## LAND USE REVIEW RESPONSE

| PROJECT NAME   | SITE ADDRESS           | REF. NO.      |
|----------------|------------------------|---------------|
| 1793 SILVERTON | 1793 SILVERTON ROAD NE | 24-124647-PLN |

The following is our response to comments based on the initial completeness review of our land use application submission of December 12, 2024. This letter addresses Completeness Review Items provided on January 7, 2025.

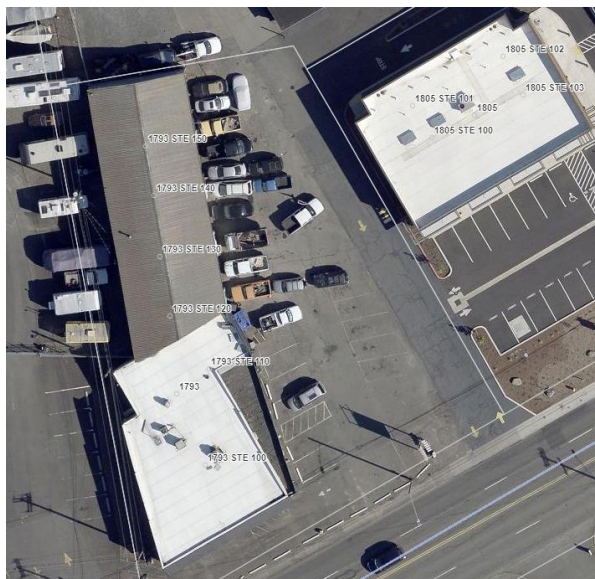
- *Vehicle Use Areas – Perimeter Setbacks & Adjustments –*

*Based on aerials of the site, the off-street parking area was recently resurfaced and reconfigured without permits or prior Site Plan Review. As such, current standards of 806 apply to the parking area. The applicant's written statement identifies three adjustments to the following standards:*

- SRC 806.035(c)(2) – Perimeter Setbacks and Landscaping Abutting Streets
- SRC 806.035(c)(3) – Perimeter Setbacks and Landscaping Abutting Interior Side and Rear Property Lines
- SRC 806.035(d)(2) – Minimum Percentage of Interior Landscaping Required

The findings for the perimeter setbacks and landscaping identify that the standard is not applicable as justification for adjustment. The standard is applicable, and applicant shall demonstrate how intent of the standard is equally or better met through a revised written statement and any supportive materials necessary to demonstrate that the criteria is met. Staff could potentially be supportive of the adjustments if the intent of the setback which is to provide separation between vehicle use areas and break up the mass of paved surfaces with landscaping can be demonstrated through the existing and/or proposed landscaping on the site. Please note that the perimeter setbacks are not required along the flag lot accessway or driveways.

*The adjustment sought for the 5% minimum required landscaping is not equally or better met by the proposed development. The parking area was resurfaced and reconfigured without prior approval so the standard is triggered and required to be met or the adjustment criteria to be clearly met by proposing landscaping that equally.*

**RESPONSE:** The property owner made repairs that included grinding and inlaying asphalt over the existing surface; however, the asphalt was not removed and replaced, and no grading was done. The amount of existing asphalt was reduced to create a landscape strip between the street property line and the building. Increasing the size of the new landscape strip or adding landscape beds within the parking area would negatively impact the development by reducing the available parking (currently limited to 20 spaces), which is well below the maximum allowed (41 spaces), and impacting vehicle maneuvering areas. The requested Class 2 adjustments for perimeter and interior landscaping are still necessary. The narrative has been revised to include the required argument. Additionally, it is the applicants understanding that the City of Salem does not prefer for the site to be brought back to those previous conditions (see below 2021 aerial) as the degree of non-conformance would be greater than that of the current conditions.

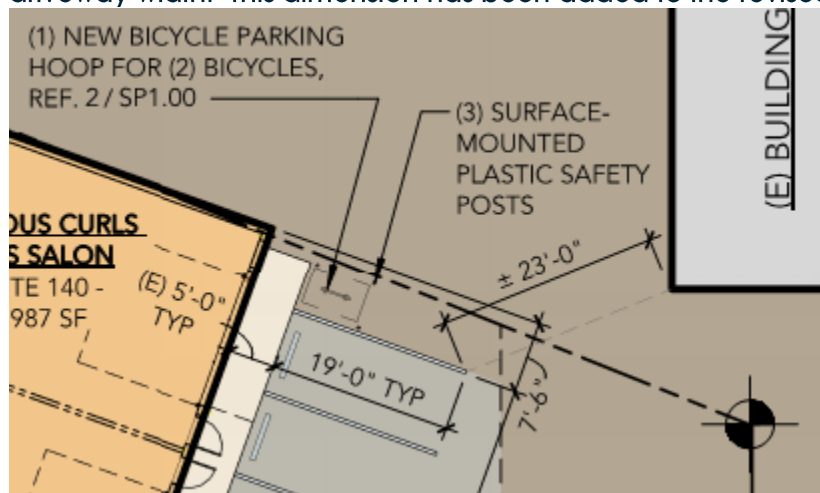
- *Driveway Width*

*SRC 806.040(d) requires a minimum width of 22 feet for two-way driveways. The proposed parking space narrows the width of driveway used to access northern property to less than 2 feet. Please revise the plans to allow a 22-foot-wide driveway to allow access to northern property.*

**RESPONSE:** The width of the maneuvering area in this location 23-feet meeting the standard for driveway width. This dimension has been added to the revised Site Plan as well.
